U.S. Army Corps of Engineers Final Environmental Impact Statement for the Savannah River Navigation Maintenance (September 1976)

OPERATION AND MAINTENANCE OF NAVIGATION PROJECT
SAVANNAH RIVER BELOW AUGUSTA
INCLUDING THE NEW SAVANNAH BLUFF LOCK AND DAM
GEORGIA AND SOUTH CAROLINA

U.S. ARMY ENGINEER DISTRICT, SAVANNAH
CORPS OF ENGINEERS
SAVANNAH, GEORGIA
SEPTEMBER 1976

SAVANNAH RIVER
 GEORGIA AND SOUTH CAROLINA
 RIVER WIDENING
 MILE 133.3 - 133.9
 SAVANNAH DISTRICT, CORPS OF ENGINEERS

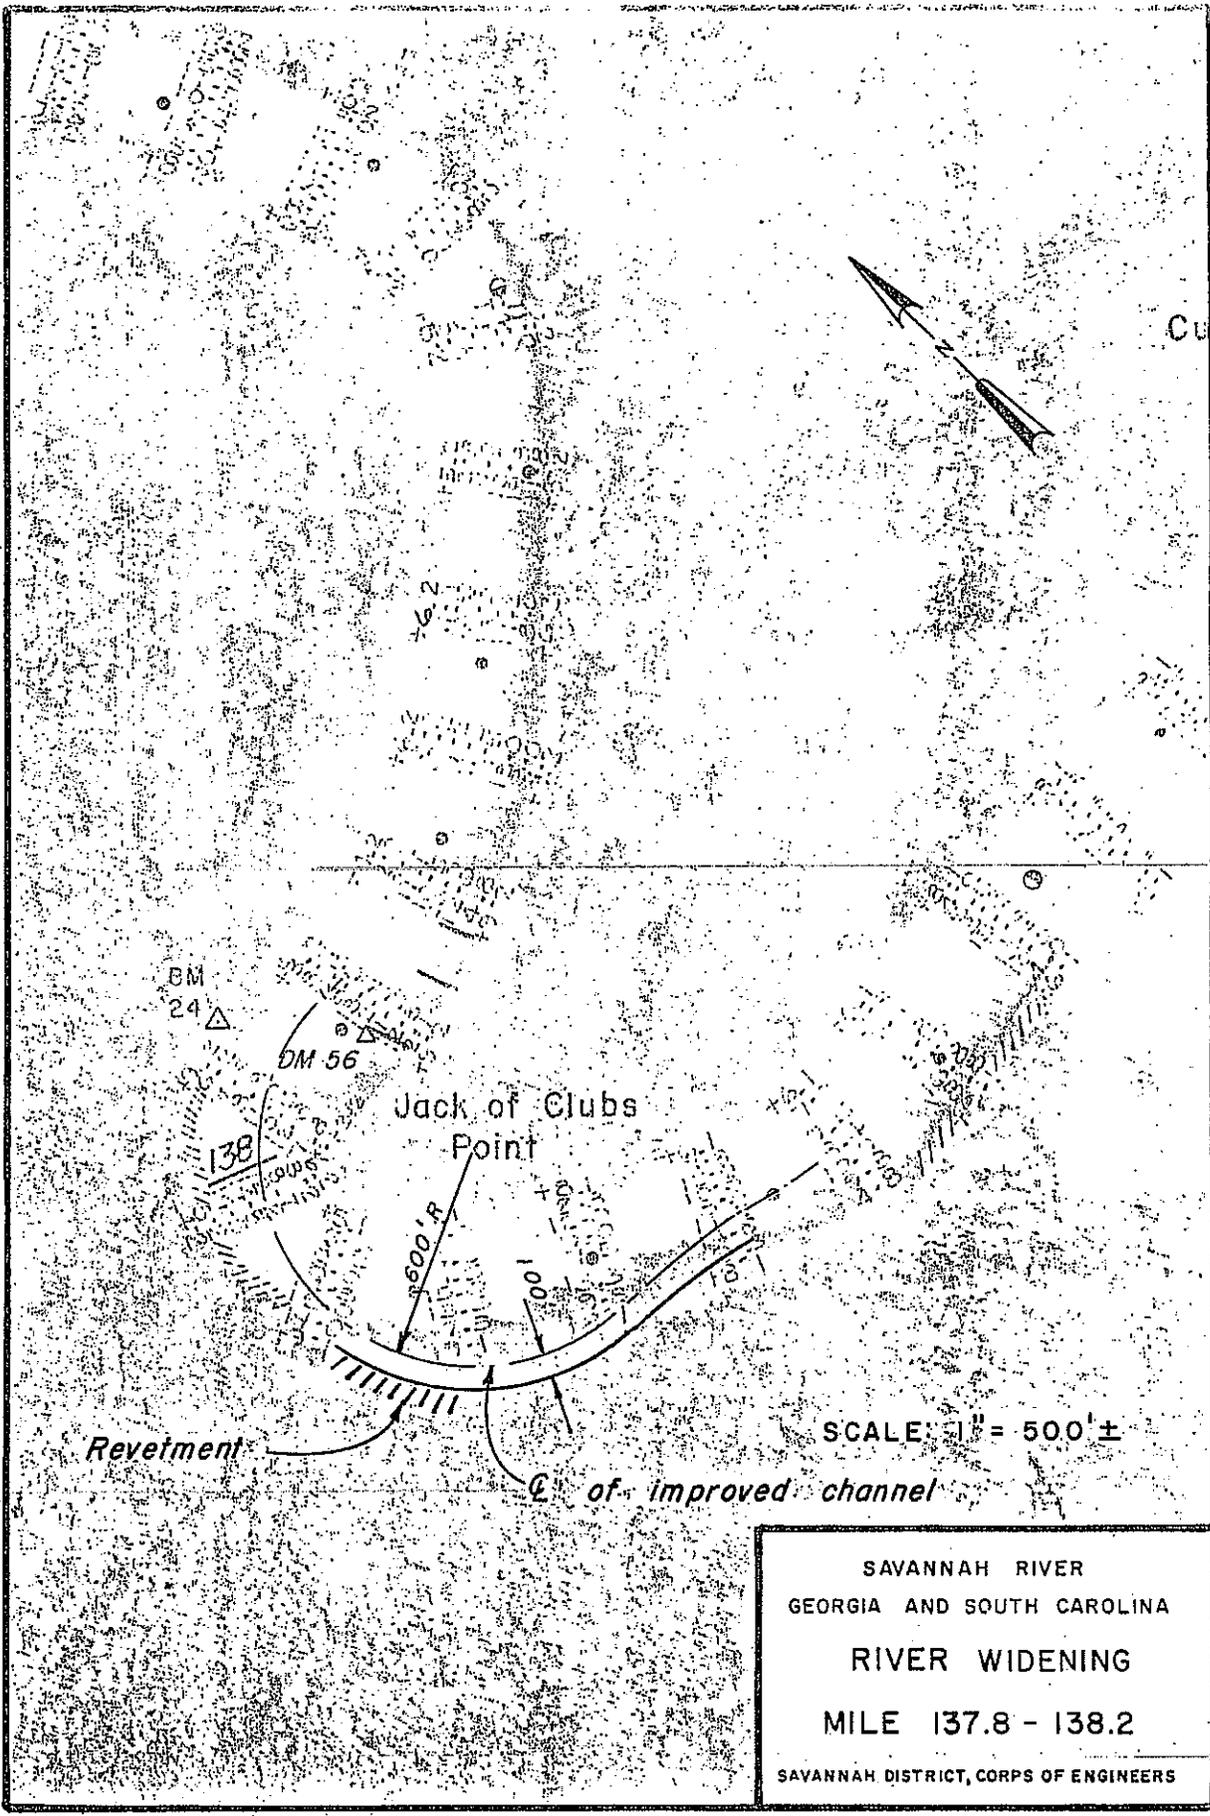
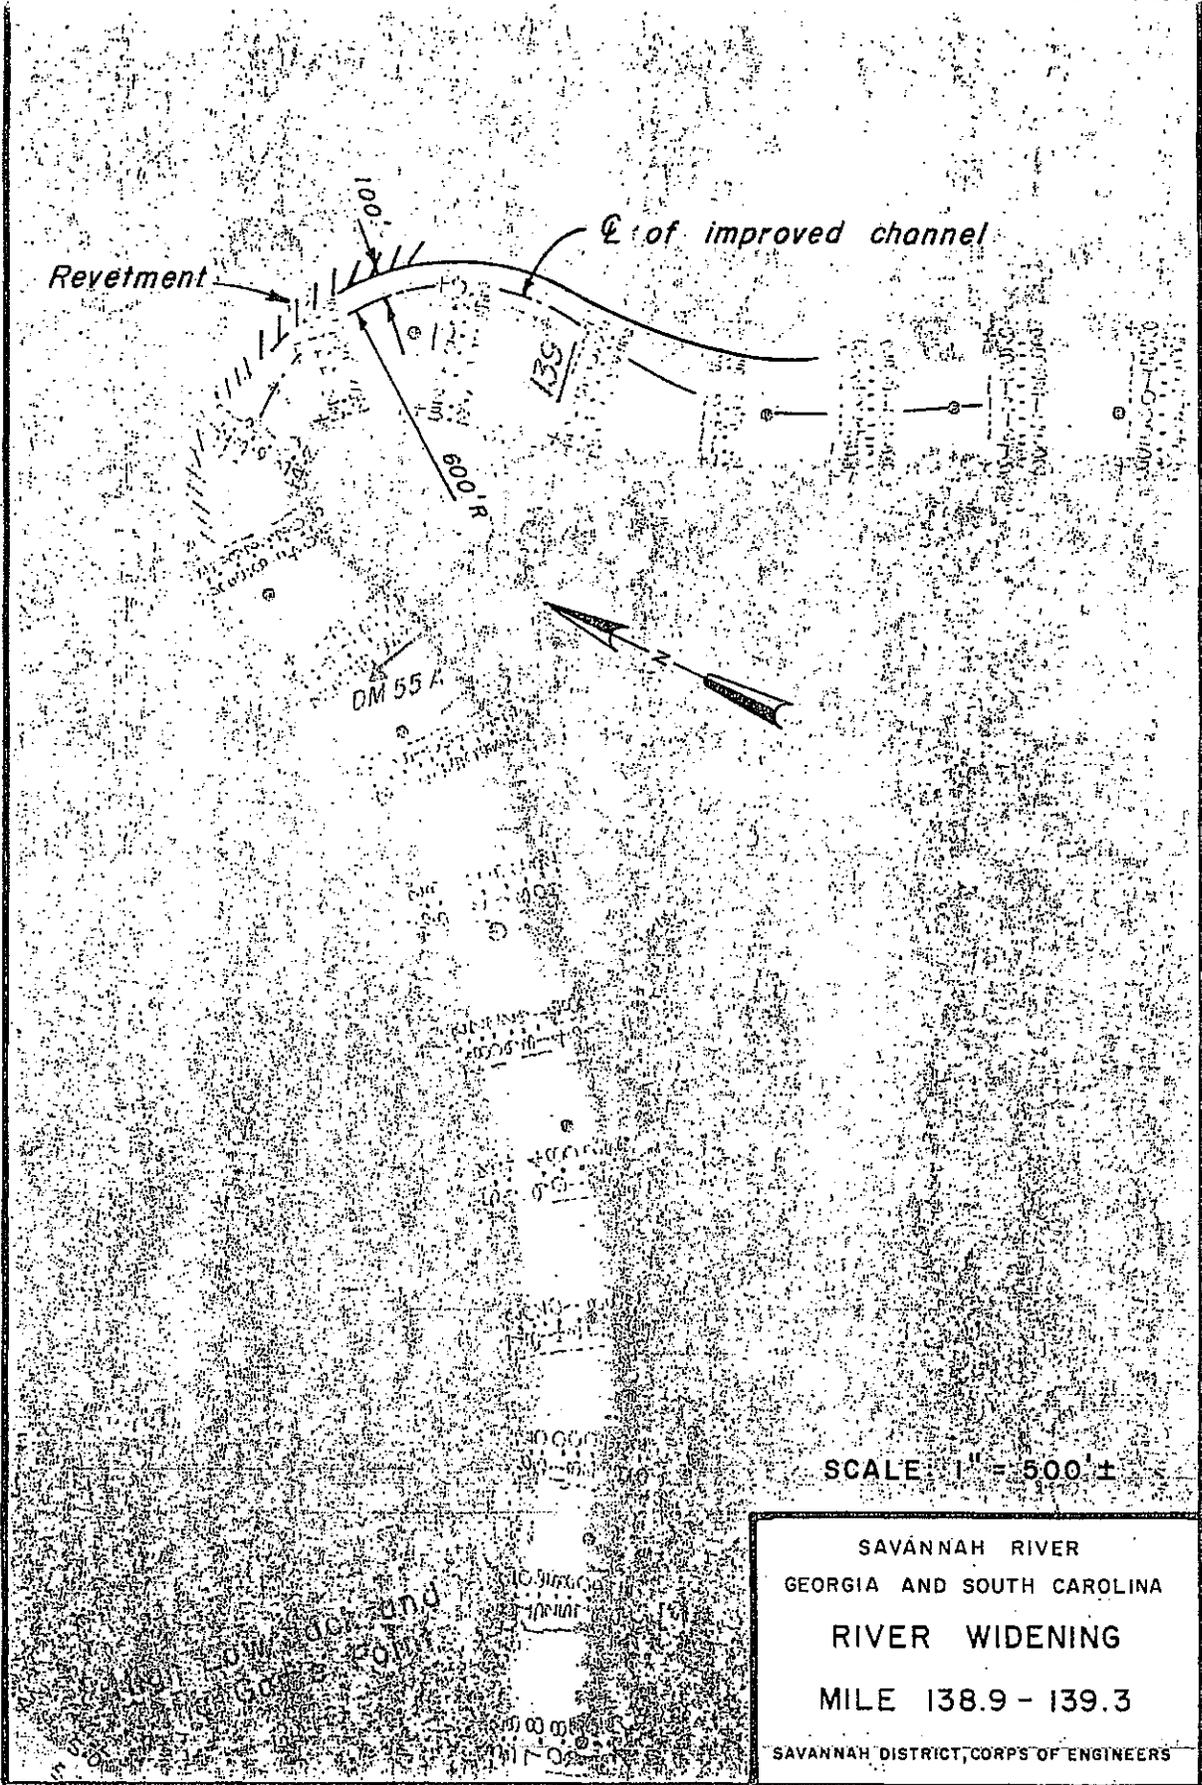
9.28 Comment: 1.00 Project Description, Page 3, paragraph 1.06, Proposed Action. This section should be expanded to include a detailed discussion of dredging methods, time of dredging, location of spoil disposal areas, construction details for additional pile dikes and revetments, and areas proposed for widening and river cutoffs. Additional figures illustrating the above features would facilitate review.

9.30 Comment: 4.00 Environmental Impact of the Proposed Action, Page 18, paragraph 4.05, Biological Impact. This section should be expanded to address specific areas designated for dredging, spoil disposal, construction of pile dikes and revetments, and areas proposed for widening and river cutoffs. The potential biological impacts will undoubtedly vary from site to site, depending on activities proposed and biological communities present.

9.35 Comment: The statement does not adequately describe location or extent of proposed river cutoffs, river widening, and the impact of the proposed construction on the associated wetland areas along the river.

9.29 Response: The dredging methods to be used in areas requiring the most intensive maintenance or construction have been added to Section 1.00 and the locations are shown on the plates of Appendix C of the Final Statement. The dredging will normally occur during the summer months due to the low water generally occurring during this time. Figure examples of typical pile dikes, river cutoffs, revetments, and general riverbend improvement have also been added in Appendix F of the Final Environmental Statement.

9.31 Response: Table 1 and the plates in Appendix C have been included in the Final Statement to give the locations of areas requiring the most intensive maintenance work. The potential biological impacts will vary from site to site; however, the general impacts will be about the same for all areas.

9.36 Response: The areas requiring the most intensive maintenance are presented in Table 1 and their locations are shown on the plates of Appendix C of the Final Environmental Statement. These modifications will not directly affect any of the wetlands along the Savannah River.
